**Sent:** 24/05/2022 3:17:23 PM  
**Subject:** DA objection letter - DA2021/1841 - 7-8 Coronation Street, Mona Vale  
**Attachments:** OBJECTION WYSMAN 2.pdf;

DA No: 2021/1841

**DEMOLITION WORKS AND CONSTRUCTION OF A SENIORS HOUSING DEVELOPMENT.**

**7 & 8 CORONATION STREET, MONA VALE**

**Figure 1 – EXISTING VIEW – LIVING / BALCONY – PRINCIPAL DWELLING**

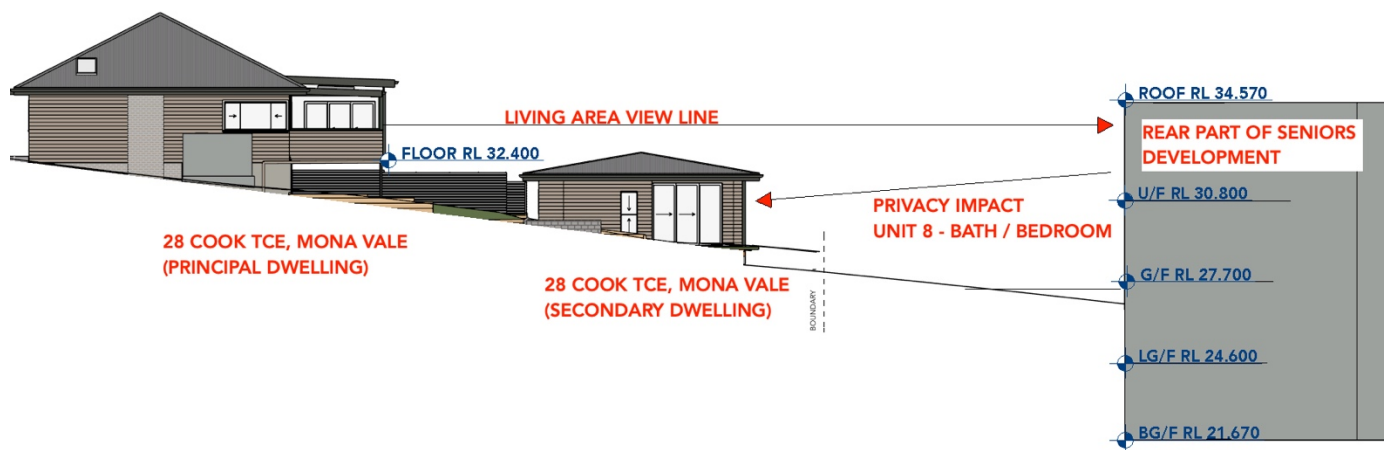
A view analysis has not been provided with the application, to indicate views currently available when view from Cook Terrace properties or the likely impact of the proposal on such views. There is insufficient information on how the proposal seeks to achieve equitable view sharing and view retention.

Given the built form of the proposed development and the span of potential impacts across Cook Terrace properties, height poles are requested to be erected to determine likely impacts to views and compliance with Clause C1.3 View Sharing of Pittwater 21DCP.

**Figure 4 – PRIVACY IMPACT VIEW LINE – SECONDARY DWELLING**

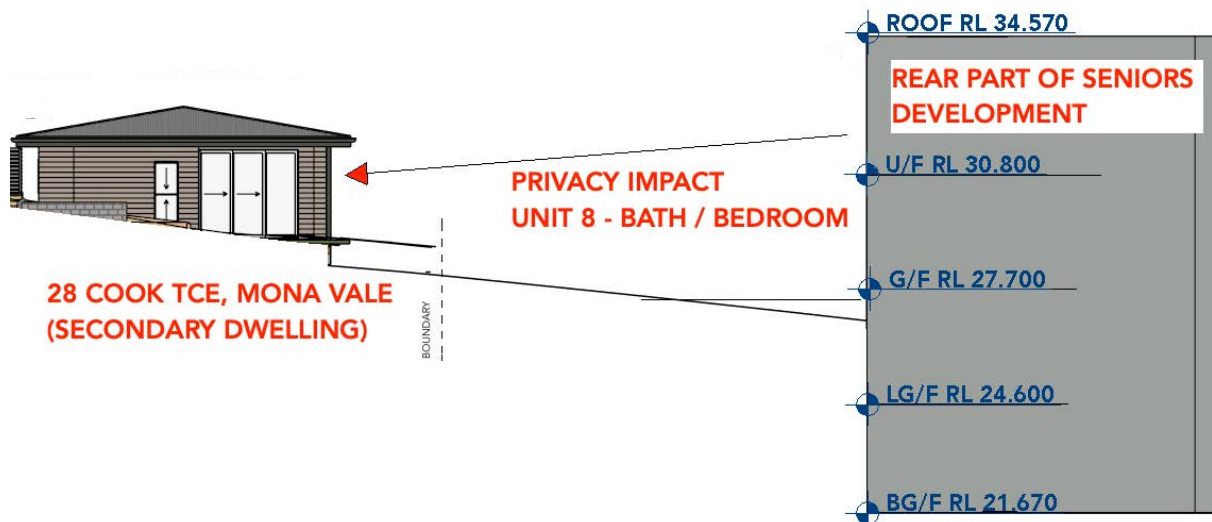
The upper floor level of the development (unit 8 - RL 30.80) are proposed 1800mm higher than the existing rear secondary dwelling floor level of RL 29.00 located 3 metres from the rear boundary.

The increased floor height together with the windows proposed in the southern wall of the bathroom & bedroom will enable direct viewing into the living

rooms and private open space area of the rear secondary dwelling of our property. All overlooking occurs from an elevated viewing angle. To address these privacy issues, we consider the following amendments should be enforced by Council:

1. Fixed obscure glazing or a highlight window to the bathroom and bedroom windows to a height of 1.7 metres above the floor level respectively.

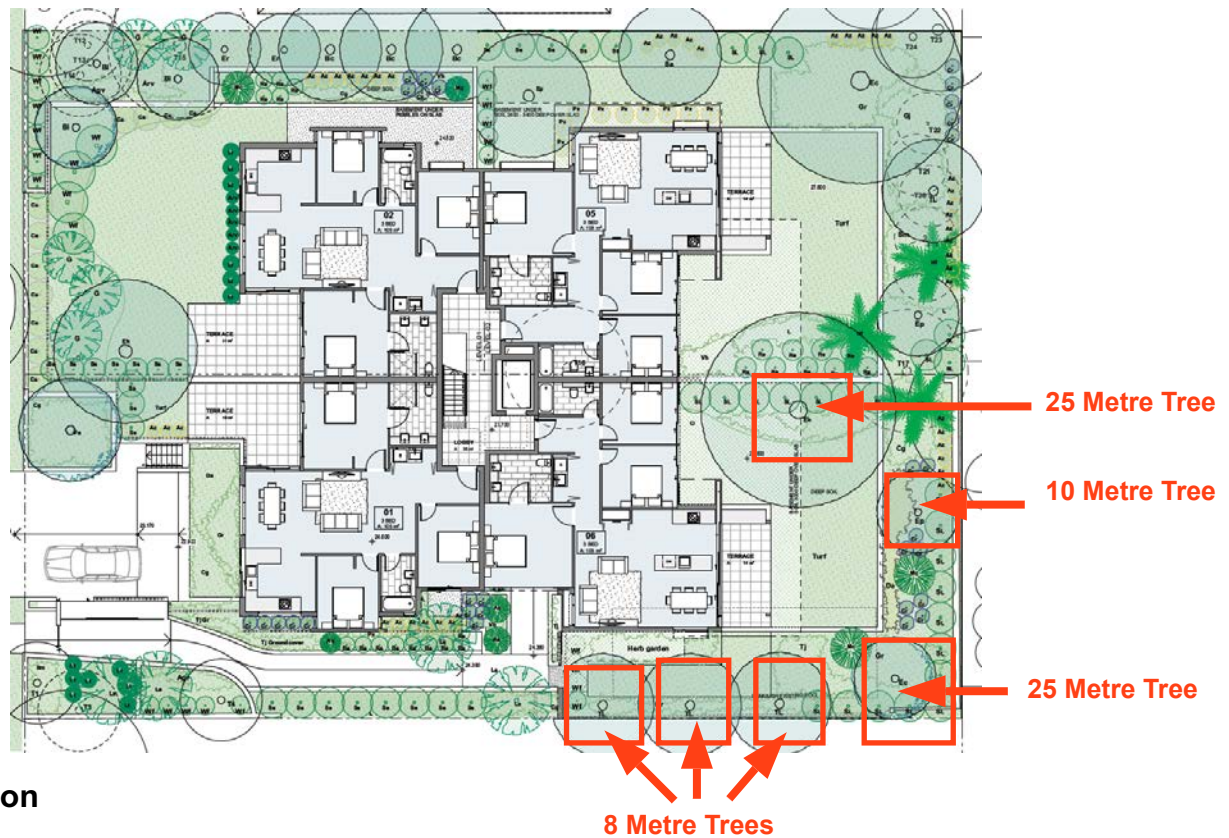
There is insufficient information provided on the position of all mechanical ventilation shafts (intake & exhaust) for the basement parking and storage areas proposed underground. The plans only indicate one (1) internal exhaust shaft adjoining the lift shaft, no intake shafts for fresh air are nominated on the plan. We are unable to determine the potential noise impacts to adjoining properties from the mechanical ventilation system required for this underground basement development.
